MILLSTONE POWER STATION, UNIT 2

DRAFT REQUEST FOR ADDITIONAL INFORMATION IN SUPPORT OF

PROPOSED TECHNICAL SPECIFICATION CHANGES FOR SPENT FUEL STORAGE.

DOCKET NO. 50-336 (TAC NO. MF0435)

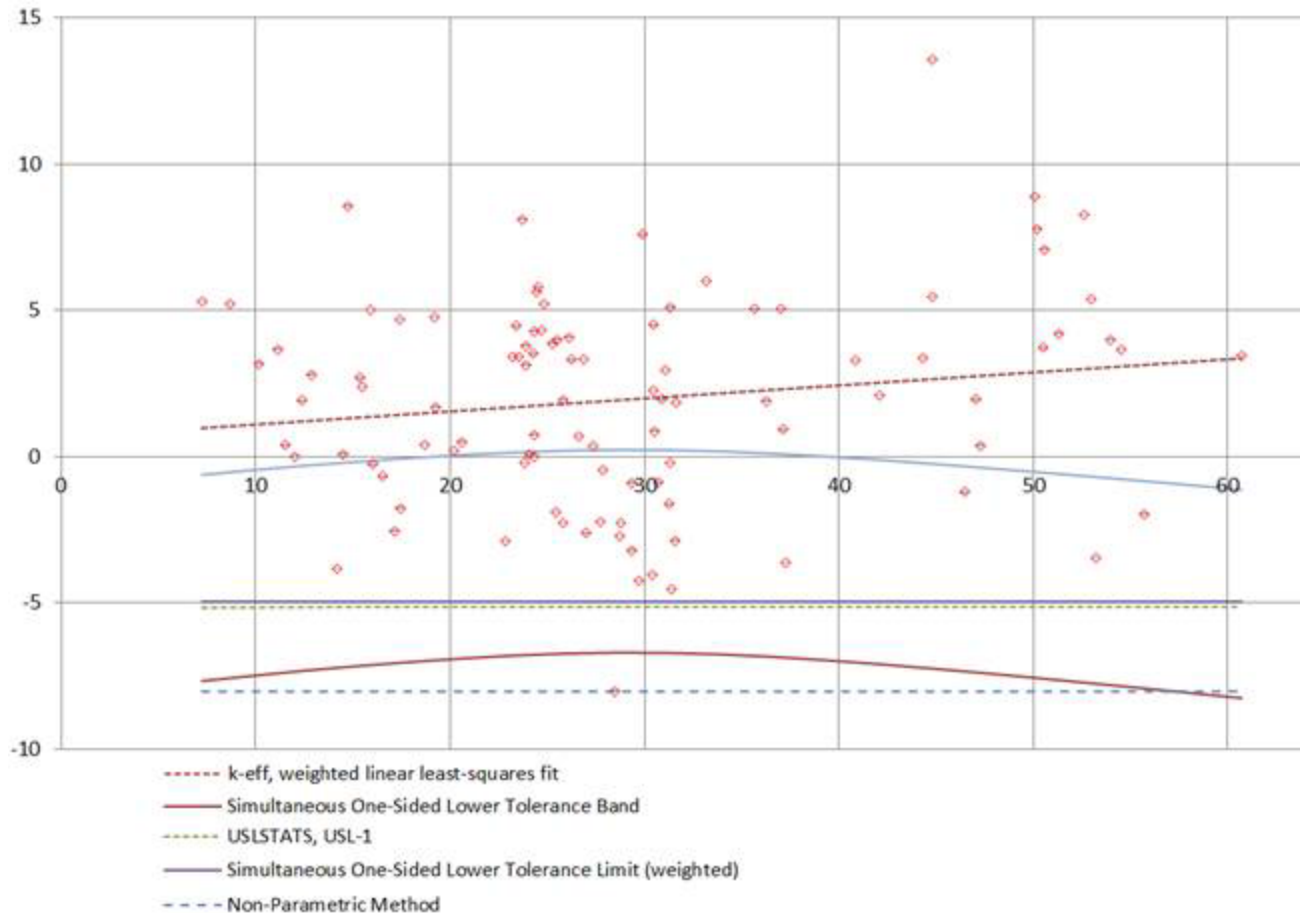
First, it is not appropriate to extrapolate outside the data points (i.e. below 7.4 GWd/MTU and above 60.7 GWd/MTU). Further, statistical analysis of the data should be used to set the 95/95 uncertainty. For data with a trend, the 95/95 uncertainty should increase near the edges of the data and within the range when the data is sparser. The figure below demonstrates a more statistically defensible uncertainty analysis.

Use of the simultaneous one-sided lower tolerance limit is not appropriate because it assumes that there is no burnup dependent trend. Use of the more appropriate simultaneous one-sided lower tolerance band yields uncertainty values significantly larger than both the commonly used Kopp letter 5% of the decrement value and the 4.55% value proposed by DOMINION. The non-parametric method does not rely on the normality of distribution. The linear least squares fit, tolerance limit, tolerance band and non-parametric analyses were performed using techniques adapted from NUREG/CR-6698. Note that the student's t score for the slope of the fit indicates that there is a 92 % probability that the slope is non-zero and the F test based on the correlation coefficient indicates that there is an 84% probability that the fit is better than random.
